## **SERVICE INFORMATION LETTER**

**TO** : All  
**FROM** : Russell Goulden  
**SL** : SIL.FDC.AS350.0008 Rev A  
**SUBJECT** : AS350 equipped with STC SR00811SE, SR01049SE  
**EFFECT** : Differential Pressure Switch  
**DATE** : Friday, May 01, 2009

### **DPS – REFERENCE PORT THREAD SIZE**

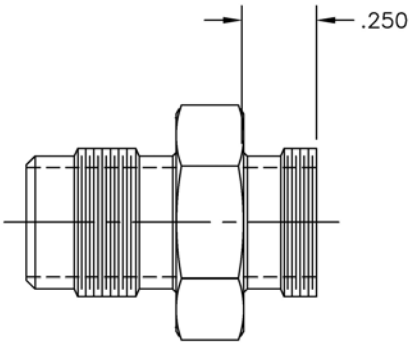
The introduction of NEW vendor DPS switch FDC P/N A486-1 introduced a compatibility issue for existing installations when the DPS is located on the engine side of the firewall ONLY.

The Field Fix is hereby cancelled and replaced by the introduction of FDC Kit available under P/N 1350K1-1.

The Kit is only required when either

- Changing the old superseded DPS FDC P/N 98505-32210 to the latest style FDC P/N A486-1 with an engine firewall side, mounted DPS.
- Installation of a new system where the early mounting configuration is preferred

The current installation configuration is A486-1 DPS mounted on the Xmsn side of the firewall, or optionally mounted on the engine side with the 1350K1-1 Kit.

1350P6-103 FITTING

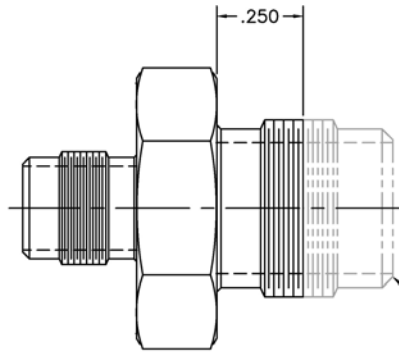
REMOVE NIPPLE AND  
THREAD AS SHOWN

DEBUR CUT END. BREAK ALL SHARP  
EDGES AND REMOVE ALL HANGING  
BURRS AND SLIVERS.  
VERIFY THREADS PER MIL-S-8879
